Proposal: Installation of a solar park to export up to 25 MW (AC) electricity, comprising up to 40,000no. photovoltaic panels, up to 7no. inverters & transformers, 2no. electrical buildings, 1no. onsite control building, boundary fencing and gates, security cameras, and associated infrastructure and engineering operations
25/00652/FUL

Location: Land East of Billing Brook and North and South of Peterborough Road Haddon

Subject: Objection - Inadequacy of Flood Risk Assessment and Surface Water Mitigation – Haddon Road Solar Park

1. Material Omission of PV Panel Runoff

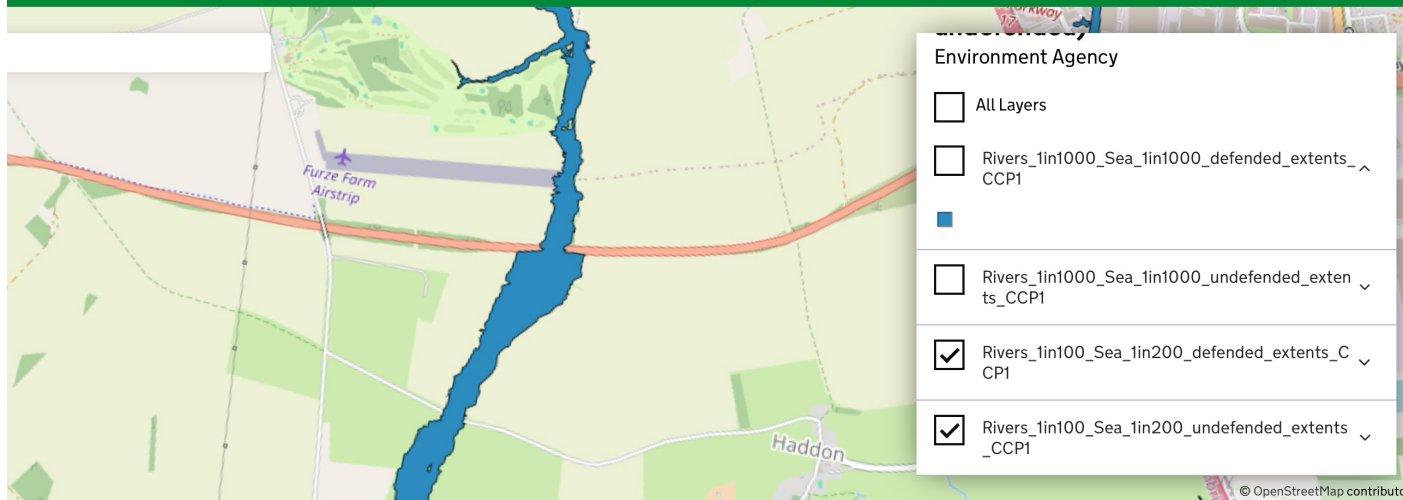
The FRA's impermeable area calculation excludes the ~100,000 m² of photovoltaic (PV) panels proposed, counting only panel supports and a handful of small buildings. This is a fundamental flaw.

PV panels shed rainfall rapidly to concentrated drip lines, producing short-duration, high-intensity overland flow, particularly on sloping sites with impeded infiltration such as the Jurassic clay and glacial till of the Northern Wolds. The omission from 40,000 PV panels leads to gross under-estimation of post-development runoff rates and required storage.
